工程指示 / 要求簡箋(E.I.)

工程指示編號：EI / 1483 / 20 修改版次：-
 工程編號：J - 837 工程名稱：觀塘裕民坊
 工程項目：Glass Cladding T2M 改百葉位置下梗玻璃(大貨)
 收件人：Maggie / 生統 / 永林 發件人：Eric Liu 日期：07/01/2020

JOB NO. : J-837
 PROJECT : URA KWUN TONG TOWN CENTRE REDEVELOPMENT (AREA 2 & 3) AT NKIL 6514, KWUN TONG, KWLOON

TITLE : PART ELEVATION OF GLASS CLADDING AT TOWER 2

名称	玻璃加工图	制图	JH	2019.3.19	修改			
材料	8 mm THK. HEAT STRENGTHENED BLUE	复核	DL	2019.3.20	日期			
颜色	TINTED GLASS (SPANDREL GLASS)	批准			图号	GL-G4

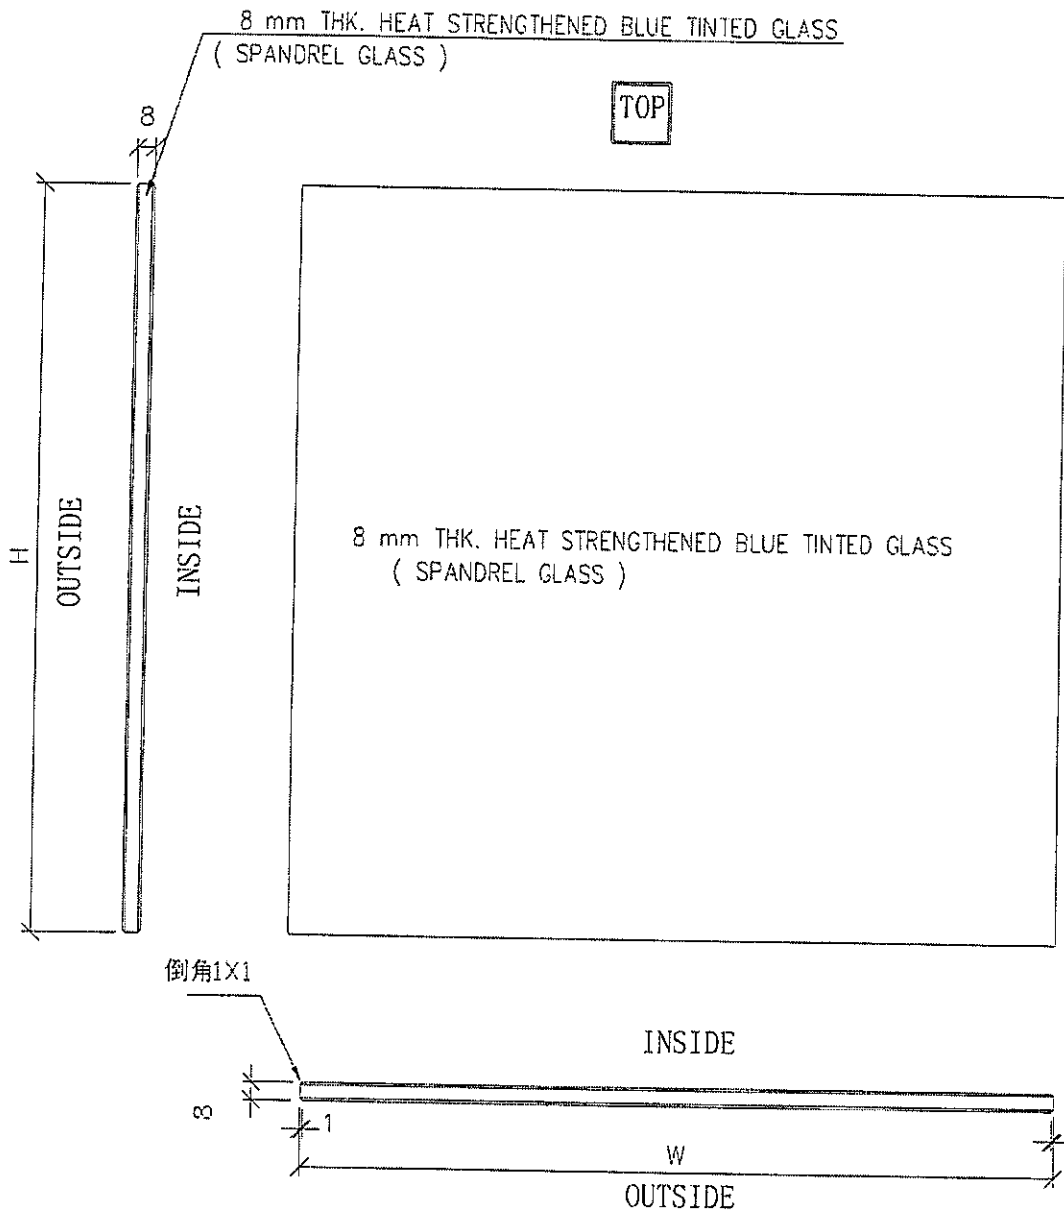
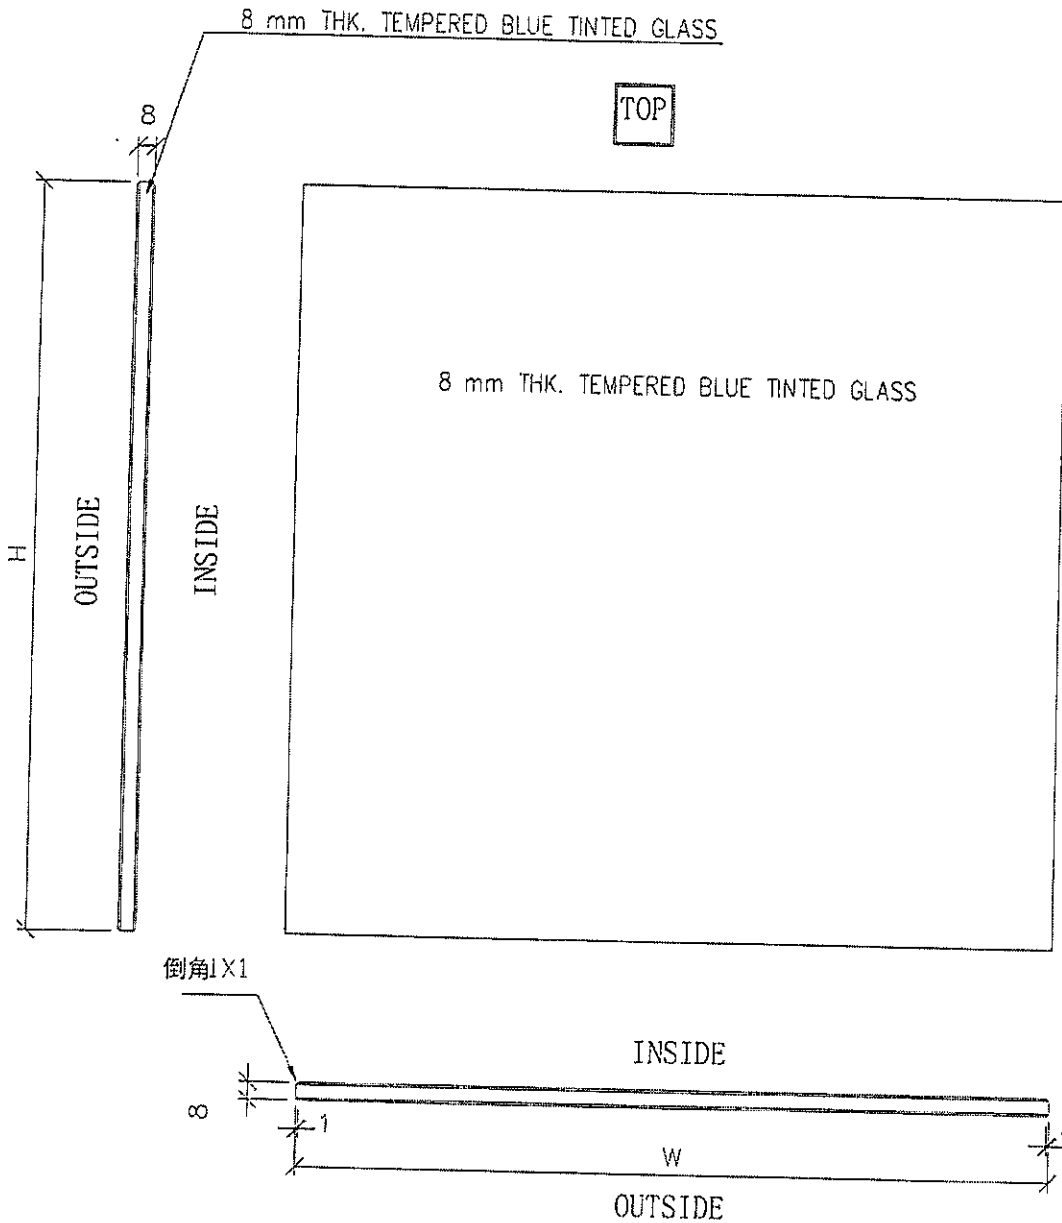
- 請按 BM 訂購玻璃送廠組裝用(T2M 改百葉下梗位玻璃，已減 8 樓數量)
 請留意: 1) 玻璃送廠，因玻璃數量少，包箱不用分座分 MO
 2) 玻璃送廠不用做保護，廠組裝鋁料打膠後再做保護
 3) 請留意玻璃加工不要固定的鋼化及熱浸標籤
 4) 玻璃出貨時需加上"可移除"標籤，標籤在室外面(注明半鋼化/鋼化)
 5) 王良: 廠完成打結構膠後，每 100 件要抽一件做割膠測試
 6) 永林: 請提供修改鋁料加工圖

T2M Mock up SI.

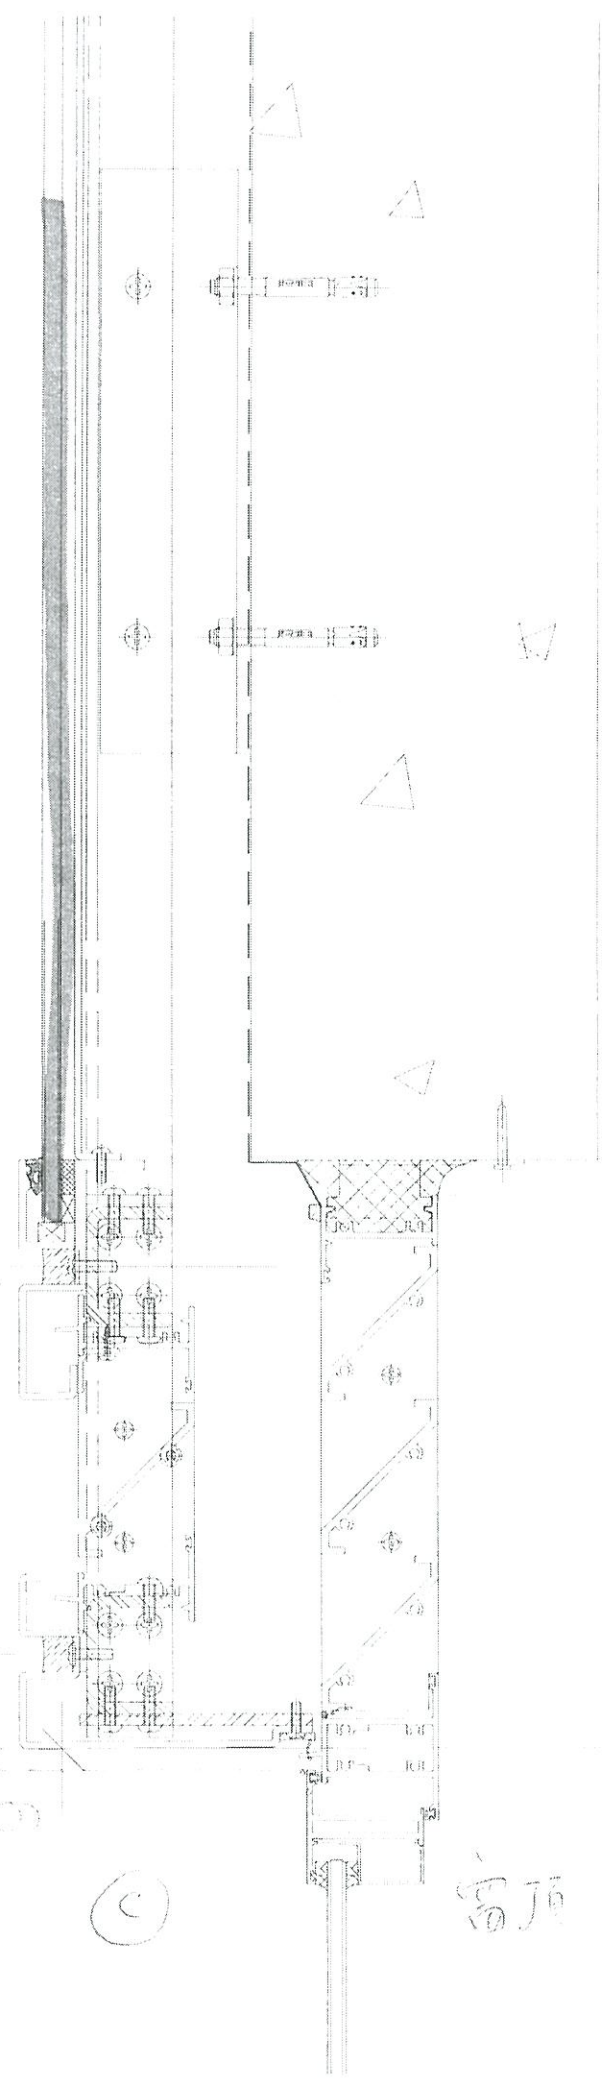
Instructions:
PLEASE FIND THE ATTACHED CHANGES IN
T2M FACADE Mock UP FOR ^{8/F} Mock UP
CONSTRUCTION. Mock UP TO BE REVIEWED
BEFORE MASS PRODUCTION.

Reasons for this Instruction:
DESIGN DEVELOPMENT UPON REVIEWING
Mock UP

① LOOSE
ROCKS
TIE AS BEFORE

② THE LINE OF
GLASS ALIGN
SAME FACE AS BEFORE

THE
PLEASE MOVE UP
